EPA (Environmental Protection Agency) Evaluation of the Mesco Moisture Extraction System under Section 511 of the Motor Vehicle Information and Cost Savings Act

EPA-AA-TEB-511-83-10

July 1983

PLATE (B)

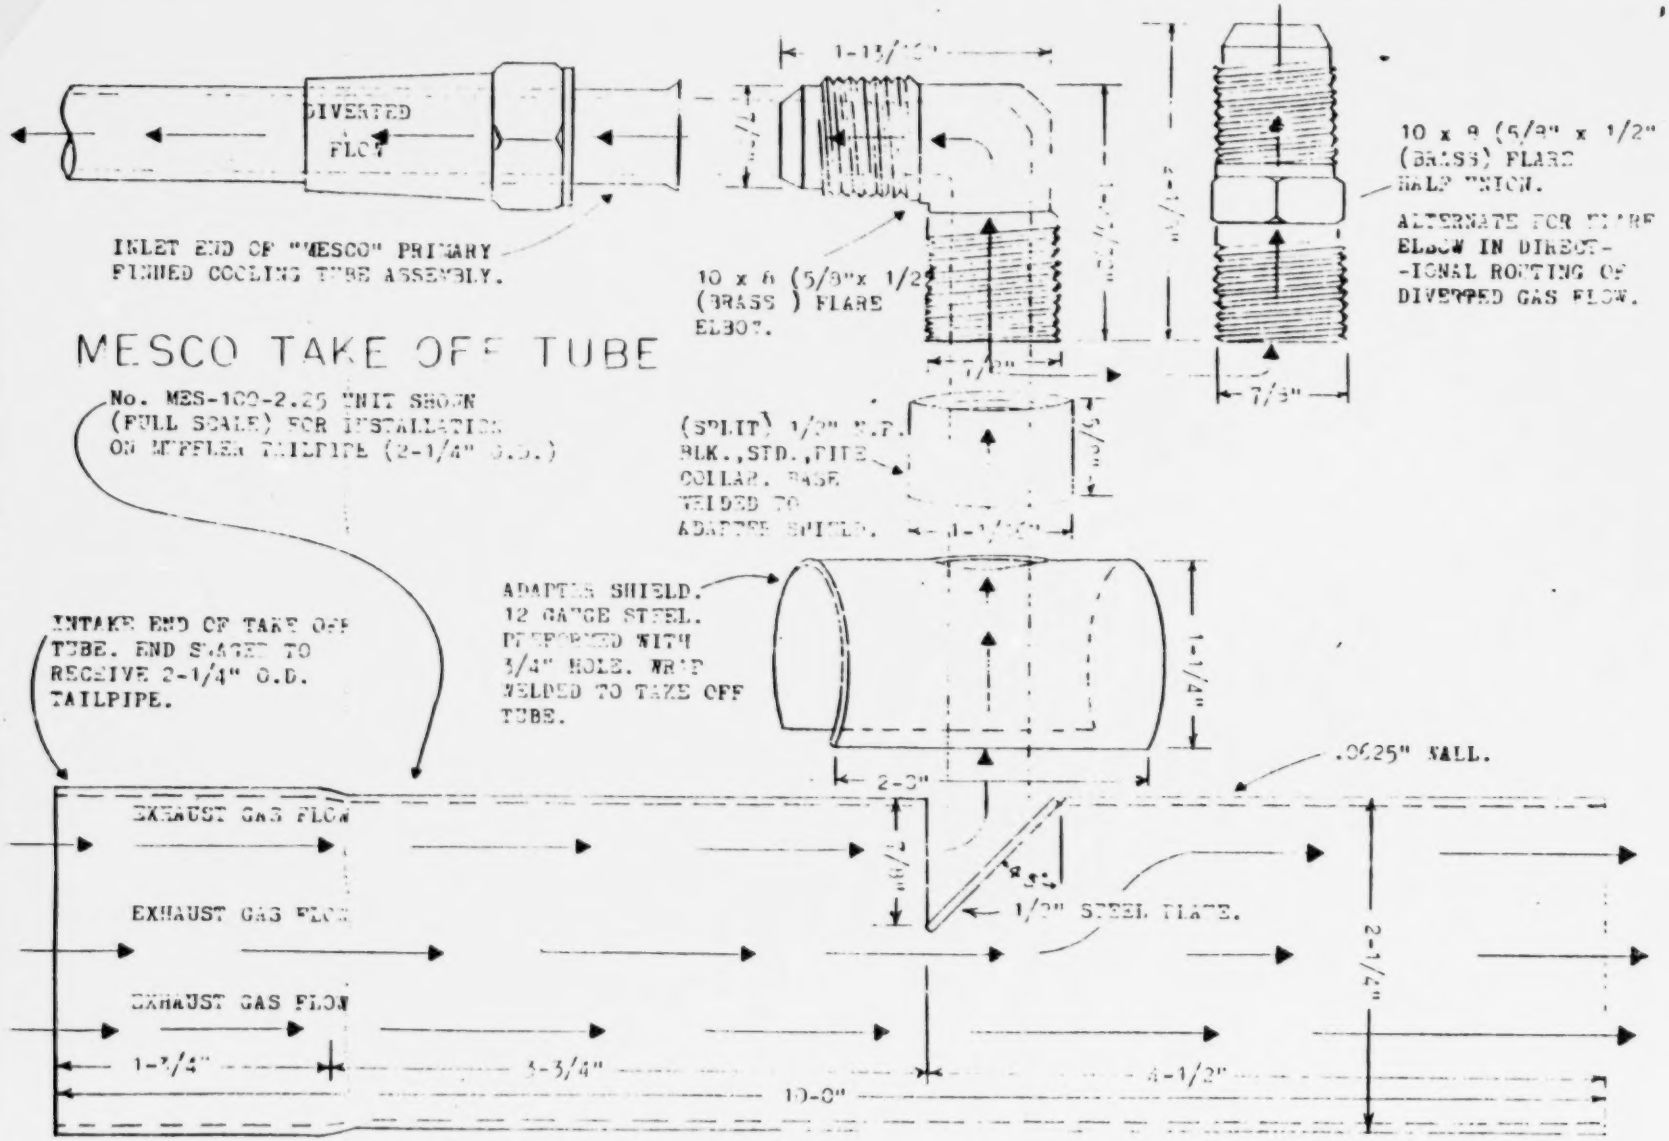
Also, another key component of the system, the "moisture extractor tube assembly" is only available for two inch (outside diameter) and larger tailpipes (Attachment D). Since most small and compact vehicles have smaller tailpipes, the extractor assembly will not fit these vehicles unless a tailpipe adapter bushing is used. These adapters are not provided with the installation kit but, they are available at many automotive parts stores.

PLATE (C)

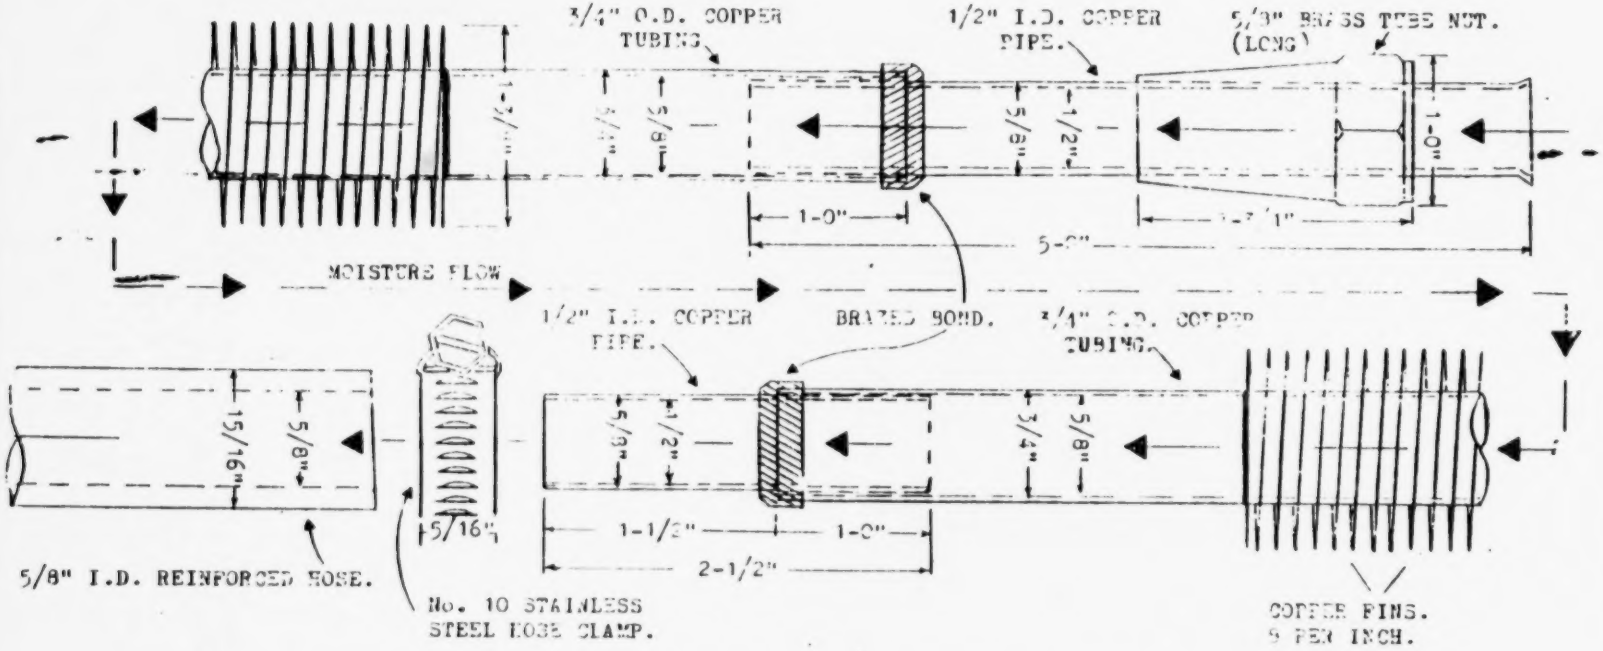
Since the primary cooling tube of the device is installed along the rear fender well and frame, it is exposed to the dirt and mud that is thrown up by the rear wheel. The cooling fins will therefore tend to cake-up with dirt since they are spaced only one-eighth of an inch apart. This build-up will actually insulate the supplemental EGR extracted by the device exhaust rather than cool it.

Thus, it will also be necessary to periodically clean the fins. To adquately clean these tube fins will probably require removal of the rear wheel and tire plus unclamping the finned tube to permit the side of it that is mounted against the frame to be cleaned. The applicant makes no mention of this problem and the need to clean the cooling tubes.

PLATE (G)

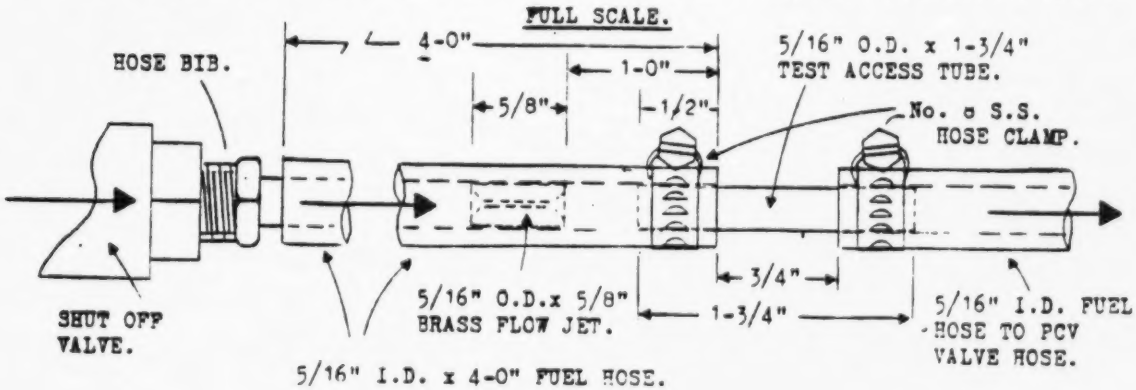
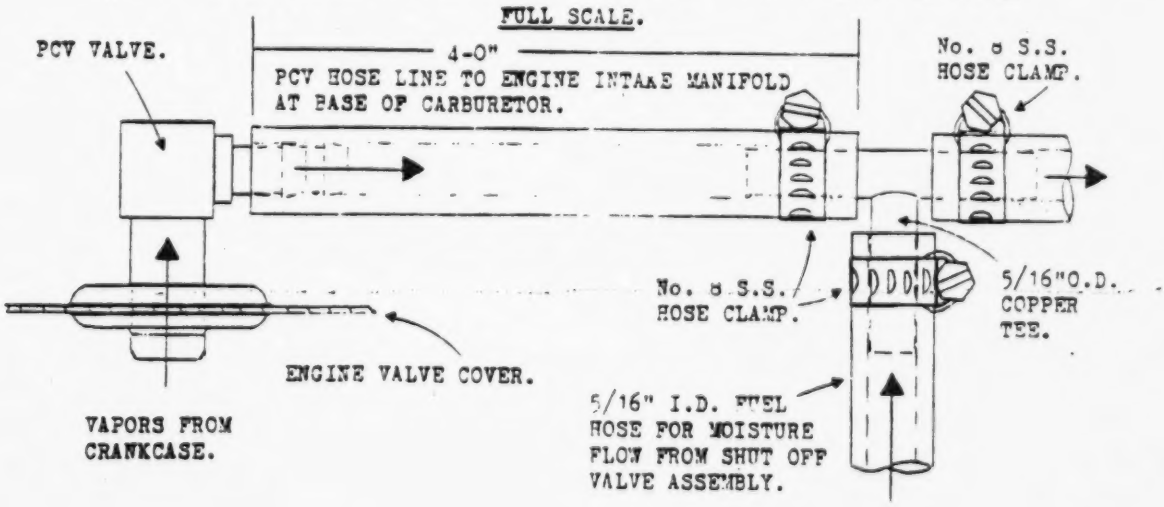
The specifications show that the "moisture flow control jet insert" (or flow control orifice) is to be sized to the cubic inch displacement of the engine (Attachment B). However, the detailed parts list provided in the installation instructions shows only one part number, MES 8, for the assembly that contains the flow control jet.
